**MAJOR PROJECT ASSESSMENT:  
Concept Plan for a Studio and Office  
Complex at the Australian Technology  
Park, Eveleigh**

Director-General's  
Environmental Assessment Report  
Section 75I of the  
*Environmental Planning and Assessment Act 1979*  
(the Act)

January 2007

Figure 8. Site Plan and Surrounding Roads

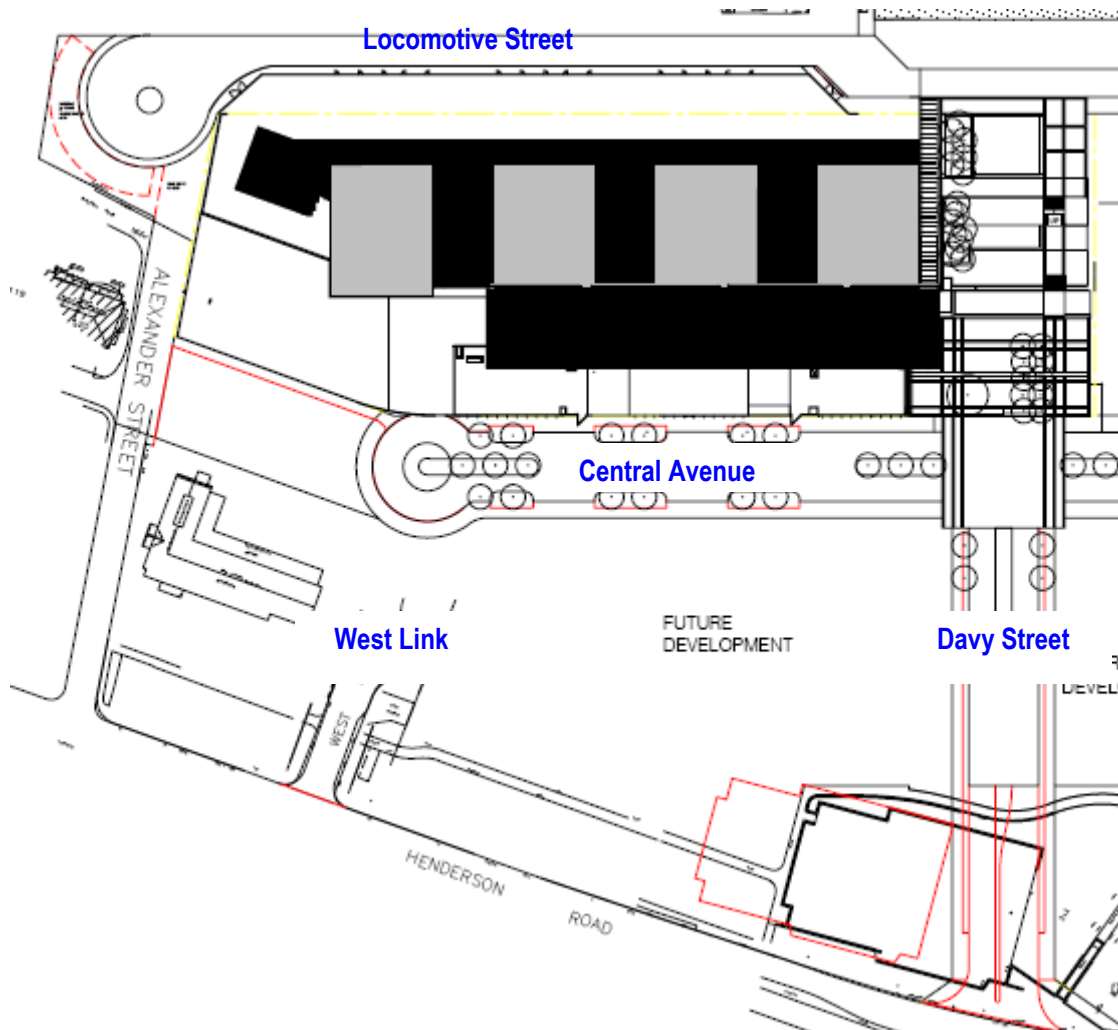
The application does not provide specific details concerning the extension of Locomotive Street in terms of technical data/drawings for the turning circle, or details of pedestrian and cycle access along this road. These details need to be resolved prior to construction of the development.

Figure 11. Illustrations of the extent of building height non-compliance

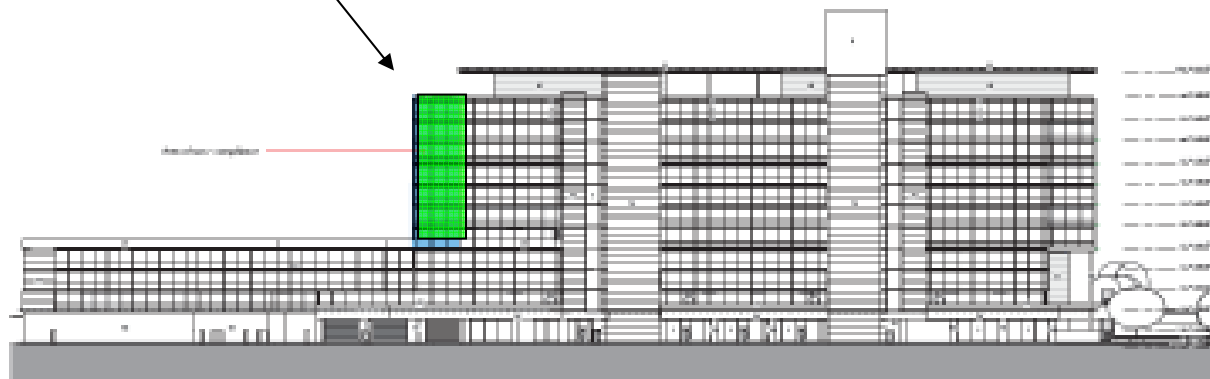
The proposal seeks a twelve storey building for the eastern end of the site and generally conforms to the height controls of the MP SEPP. However, an approximately 15m deep section of the eleven storey element extends 8.4m into the four storey height zone, raising a non-compliance with this control.

Area of non-compliance – 12 storey element protruding into 4 storey maximum area

The Proponent is seeking variation to the height requirement on the following grounds:

The mechanism provided by State Environmental Planning Policy No. 1 – Development Standards (SEPP No. 1) is not required to vary a control contained within an Environmental Planning Instrument (in this case, the MP SEPP) for an assessment carried out under Part 3A of the Act. Nonetheless, the principles of SEPP No. 1 are considered relevant in the consideration of variation to a development standard. That is, where strict compliance with the subject standard would, in any particular case, be unreasonable or unnecessary or tend to hinder the attainment of the objects specified in section 5 (a) (i) and (ii) of the Act, variation is considered acceptable.

Figure 13. Illustration of proposed wind baffling

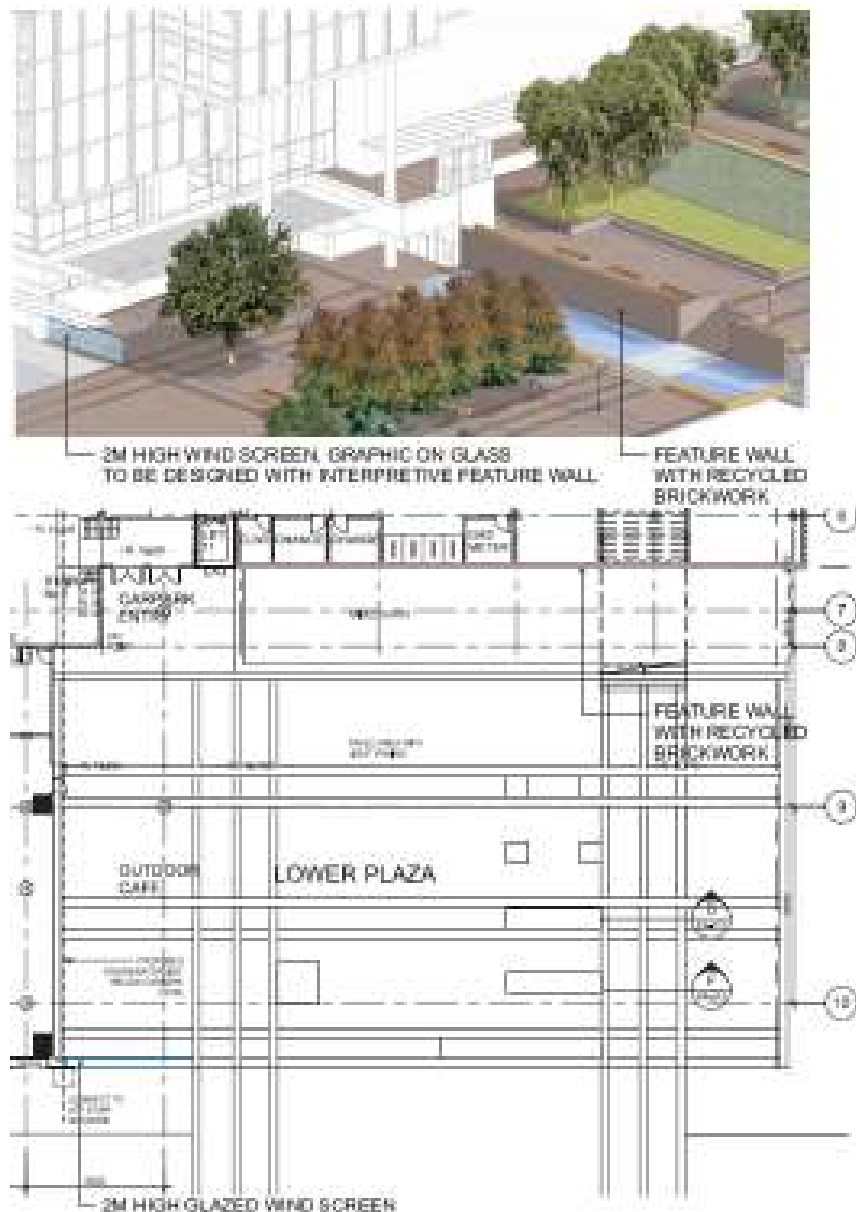
The Statement indicates that downwash generated by the proposed development, in conjunction with sidestreams generated by the southerly winds may produce unacceptable wind conditions at the south-eastern corner of the development in the location of the café and public plaza. The Statement indicates that this potential problem can be ameliorated with the use of treatment solutions, such as localised planting or localised awnings/canopies, or a combination of these. However, the effectiveness of these treatments can only be determined with wind tunnel testing.

The wind impacts to the south-eastern side of the plaza adjacent to Central Avenue are marginally higher than within the outdoor dining area, however, they generally do not exceed the 'Davenports Comfortable Walking Criterion' and are therefore considered acceptable. Wind tunnel testing for the "landscaped accessible roof" demonstrates excessive wind impacts. However, the "landscaped accessible roof" is to be deleted via a condition of approval as previously discussed in Section 6.1 of this report.

including planting and baffles being implemented. The data from the wind report indicates that the wind levels around the outdoor dining area of the plaza peak for a southerly wind at approximately 11m/s (test Point 10). However subject to mitigation measures, the winds impacting upon the outdoor dining area and the footpath on the southern side of the building generally do not exceed 'Davenports Short Exposure Criterion' (i.e. between 3.5m/s and 5.5m/s), and Point 10 is subjected to a significantly reduced wind speed of approximately 2.5m/s. It is noted that the mitigation baffle screens and planting are not consistent with the landscaping plan, and accordingly a condition of approval requires amendment to the landscaping plan to incorporate the measures of the Wind Environment Statement.
